Technical Bulletin

Model No: SLC310

Model Name: Compact 3nm Solar Marine Lantern

Image:

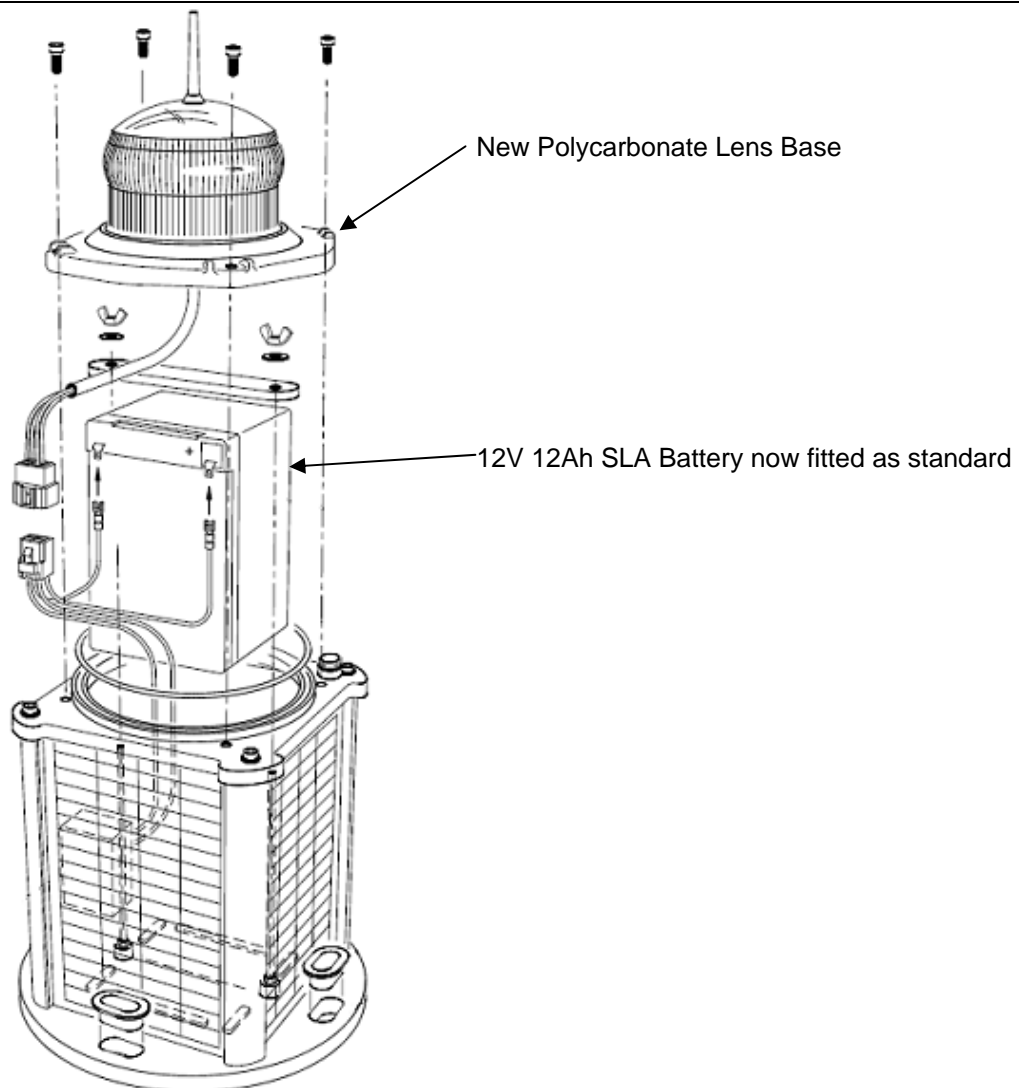
Description of Change	Reason for Change	Effective Date
Battery size now increases from 7Ah to 12Ah.	<p>The SLC310 lantern will now be offered as standard with a 12V 12Ah SLA battery. This is the same SLA battery as found in the larger SLC420.</p> <p>This will allow the SLC310 to increase autonomy, run at higher duty cycles or be positioned at higher latitudes.</p> <p>Sealite can now fit the larger battery because we are using the same casting as found on the SLC420. Sealite has also altered the polycarbonate lens base to fit the larger casting.</p>	July 2009
